**Source:** NOKIA

**Title:** Comments to FDD UE Transmission mask

**Document for:** Discussion

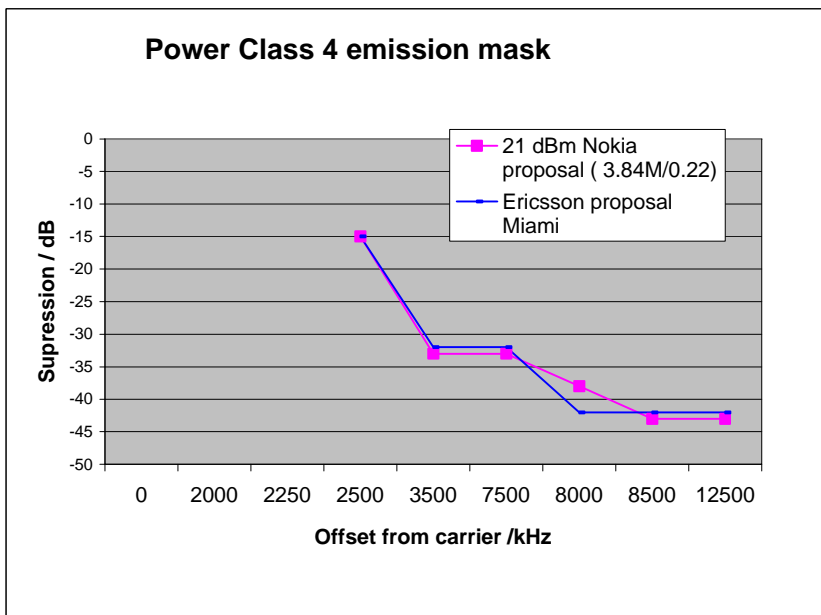
Tdoc R4-99302 is based on 4.096 Mc/s rate, hence the emission mask values should be reviewed to reflect TSG RAN#4 meeting decisions. The liason statement from our working group stated that with new chip rate ACLR1 and ACLR2 values will be 1 dB tighter. This impact is shown in section 2.1.

We would like to revise the shape of emission mask so that the transition regions are same shape. The 7.5-8 MHz region could be 1 MHz wide, 7.5 –8.5 MHz as is the case in 2.5-3.5 MHz range. This for the reason that transition bands width are not likely to be different in different sides of ACLR1 band.

As stated in Tdoc R4-99302, the proposal is concerning only power class 4, + 21 dBm terminal. We feel that the emission mask should be relative to output power, and all power classes needs their own masks. With one single mask applied to all power classes will mean the ACLR requirement to be tighter with same amount as the power difference to class 4. The implementation aspects have been discussed in previous meetings and are well known. As the complexity in implementation increases, the likelihood of having high power class terminal will decrease. This might complicate or delay the introduction of services needing higher power classes.

The spurious emissions in PHS band will fall into ACLR3 region in current specification. We feel that this frequency band is too close of our own operating frequencies to regard it as an absolute emission limit. For higher than 21 dBm power classes this emission level will generate additional requirements for ACLR. It should be considered wheter the emission limits dealing PHS emissions should also be relative to output power. This requirement would then be as discussed previously relaxed compared to 21 dBm terminal.
